April 12, 2018
Staff Report to the Southeast Town
Design Review Committee

CASE #MPL2017-10047
SUB2017-10055
Item # 3

LAKE NONA MIXED-USE DISTRICT

PRELIMINARY PLAT

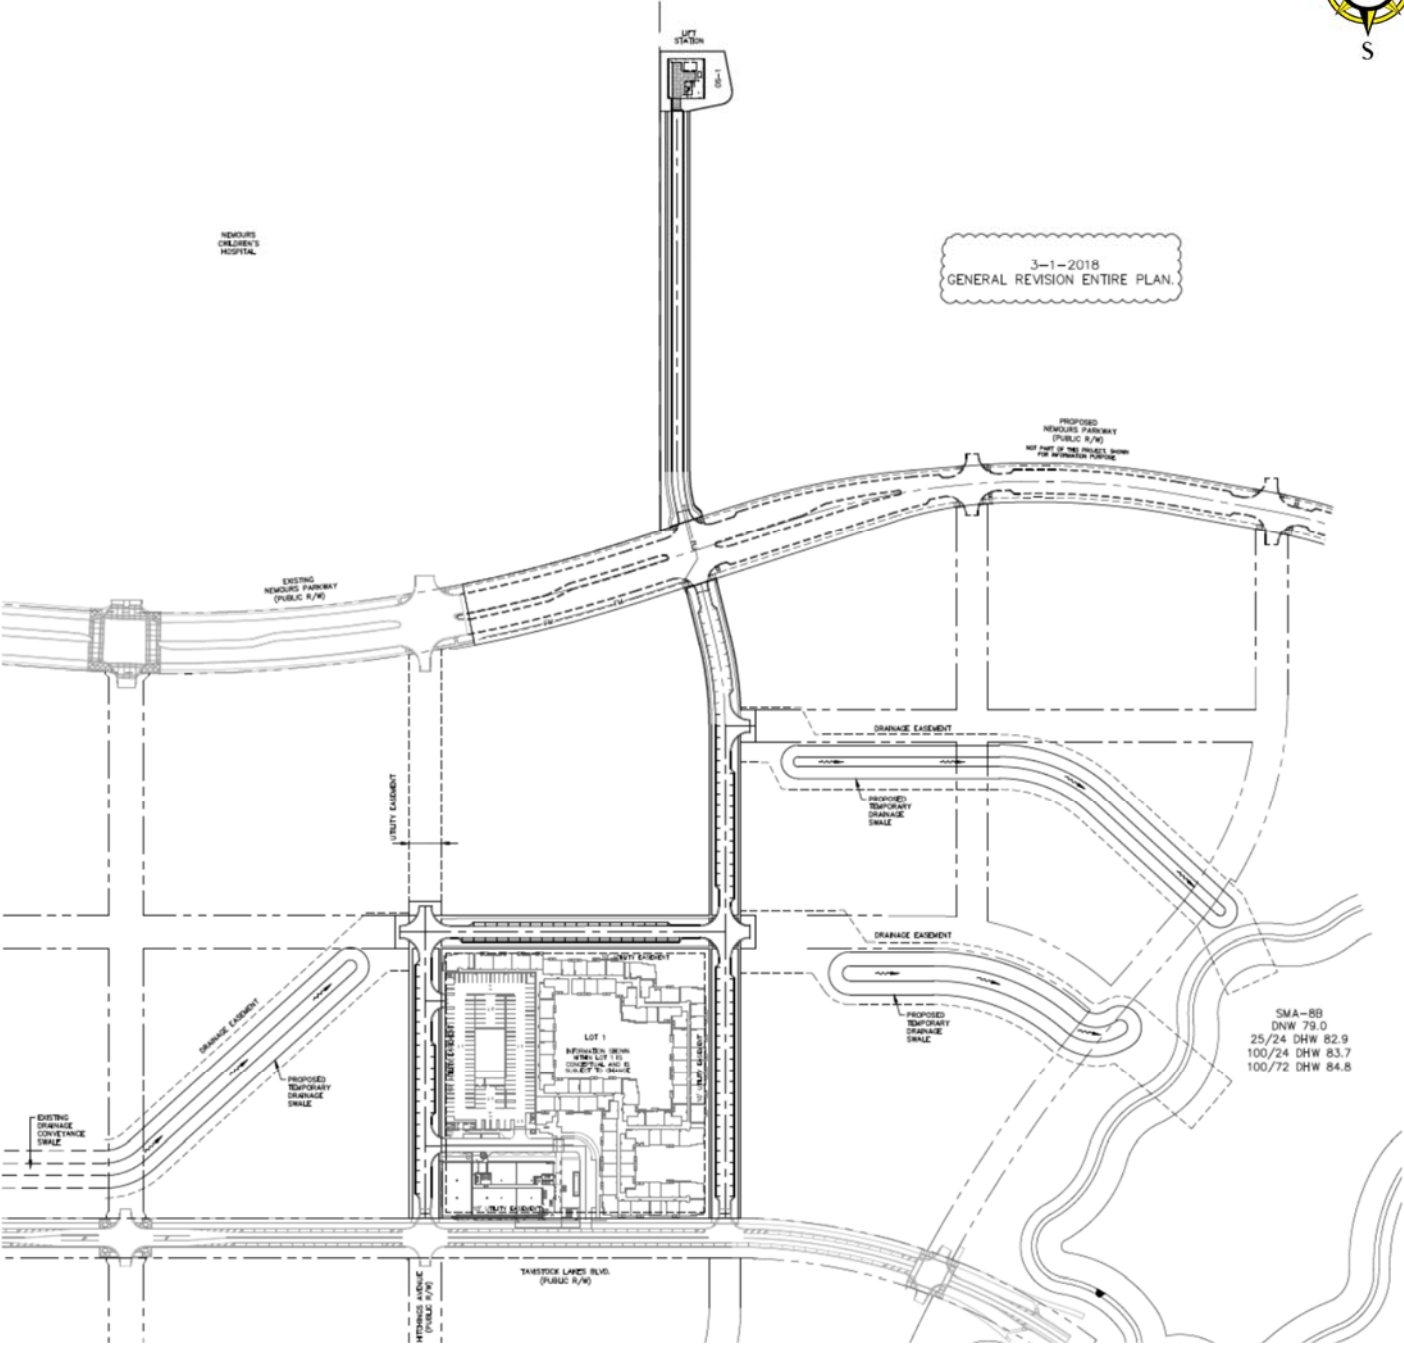
1. The City owned sewer mains to be installed within an easement as depicted on Plat sheet 4 (until the Public Street is constructed in the future) shall have a stabilized base suitable for access with heavy equipment.

2. On the typical cross-sections depict the location of force mains where applicable.
3. The construction plans shall depict the size and location of existing gravity sewer mains, reclaimed water mains and force mains. Sheet 4 of the Plat does not match the City's records with regard to existing Water Reclamation facilities.

ROAD CROSS SECTIONS

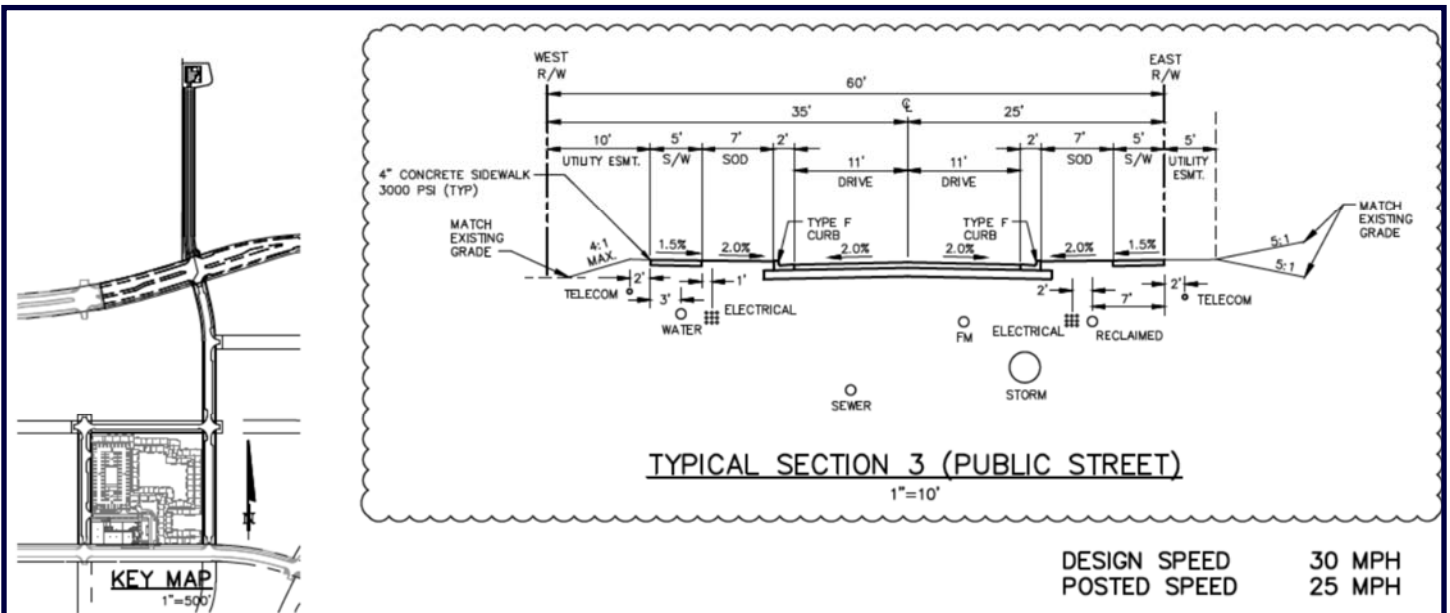
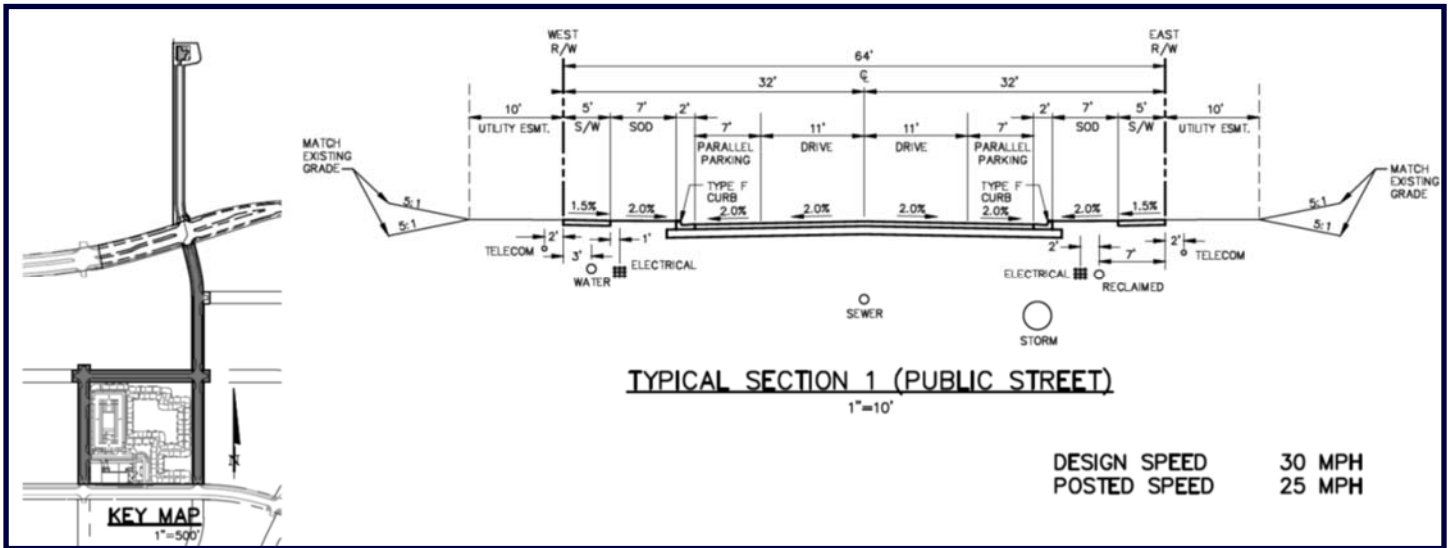
- d. Typical Section 3, the road shall be posted as "No Parking".
- e. Due to concerns with speeding and pedestrian and bicyclist safety, Transportation Department is requiring that raised crosswalks be placed at locations where the cross section changes and where there are pedestrian and bicyclist attractors. Initial review indicates that 6 to 8 raised crosswalks would be appropriate throughout the District. The City Transportation Engineer reserves the right to review and approve the final locations of the raised crosswalks.
